Mount Munro: s92 Further Information Request – Landscape

This letter sets out my response to relevant aspects of a Further Information Request received from Horizons Regional Council, Greater Wellington Regional Council, Tararua District Council and Masterton District Council for the above project, dated 6 July 2023.

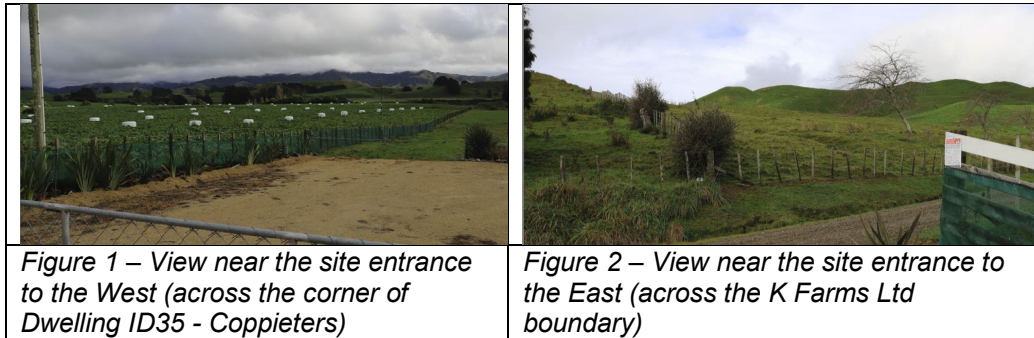
- 1. The roading alignment included in the Tonkin + Taylor Indicative Roading Section Plan essentially adopts an alignment that is positioned central to the Turbine Consent Envelope and Turbine Exclusion Zone corridors. It is considered that the effects conclusions made within the Landscape Effects Assessment, in relation to the earthworks associated with the construction of the internal road network, are credible based on the demonstrated alignment and prepared visual simulations. However, there is the potential for a considerably larger scale earthworks within these proposed consent corridors, particularly when it is noted that the specified road width “don’t include feathered edges, drains, or removal of banks on the road shoulders to enable the transport of turbine blades”¹. Please confirm that the scale of earthworks (cut/fill), associated with the final alignment of the internal road layout, is consistent with the level of effect assessed in the Landscape Effects Assessment.*

The earthworks modelling used in visual simulations was prepared by Tonkin and Taylor (v10.01). This includes an understanding of cut and fill batters where necessary to support an indicative access alignment and inform the assessment of potential landscape and visual effects. The dimensions in the report refer to road widths only. The full extent of earthworks included in the model incorporates indicative batter slopes which enable feathered edges, drains and removal of banks on the road shoulders to facilitate the transport of turbines.

Since the Landscape Effects assessment was lodged, I have been provided an update to the earthworks model (V10.04) as represented in Figures 4 and 6 of the Landscape and Visual Effects Assessment Graphic Supplement. This relates to facilitating access to the south of the laydown area along Old Coach Road and associated bridge crossing along Makakahi tributary as assessed. There is no change to the indicative internal earthwork’s layout as modelled or assessed within the windfarm.

I can therefore confirm that the scale of earthworks which have been assessed have incorporated an allowance for earth worked batters beyond the specified road widths and within identified exclusion zone corridors. Once completed, resulting batters will be re-established in grass. This understanding has informed the overall level of effect identified within the Landscape Effects Assessment.
